## PUBLIC UTILITIES COMMISSION

March 03, 2022

PG&E AL 6286-E, 6286-E-A, and 6286-E-B  
SCE AL 4559-E and 4559-E-A  
SDG&E AL 3822-E, 3822-E-A, and 3822-E-B

**Subject: Staff Disposition of: PG&E AL 6286-E, 6286-E-A, and 6286-E-B; SCE AL 4559-E and 4559-E-A; and SDG&E AL 3822-E, 3822-E-A and 3822-E-B -- Modifications to Rule 21, Generating Facility Interconnections, Pursuant to Decision 20-09-035 Ordering Paragraphs 7, 49, 50 and 52 (SCE only)**

**Figure 1: PCS Operation Responding to a Rapid Loss in Load**

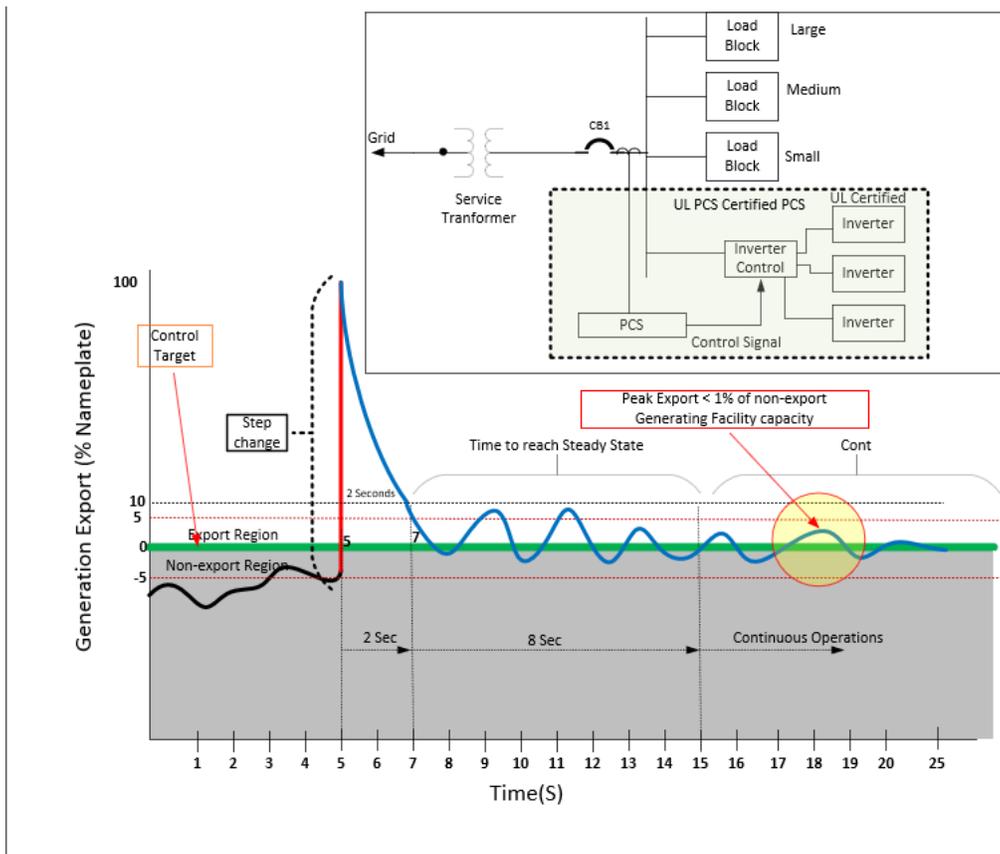
Figure 1 shows the concept of steady state for a 2 second ([s]) OLRT. Between time (t) equals (=) zero to t=5 [s] the generating facility is not exporting power to the electric grid and all power produced by the generating facility is being absorbed by the existing load (black squiggly line). At t=5 [s] there is a sudden drop in load and the facility starts exporting power to the electric grid (vertical red line the “step change”) more than the allowed limit (horizontal green line). The period between t=5 and t=7 [s] is the 2-second OLRT during which time the PCS attempts to bring the export power value back down (blue descending line) to the allowed limit. But the PCS may not reach the allowed limit within the OLRT and there could be a time after the 2 [s] OLRT where the PCS exports and absorbs small amounts of power (blue squiggly line). To account for this operation, the IOUs have added, after the OLRT, an 8 [s] period of time for the PCS to reach steady state--the PCS must reach steady state within 10 [s] (at t=15) after the step change. After t=15 [s], during continuous operation, the PCS will keep the export value bounded and below a pre-determined value.
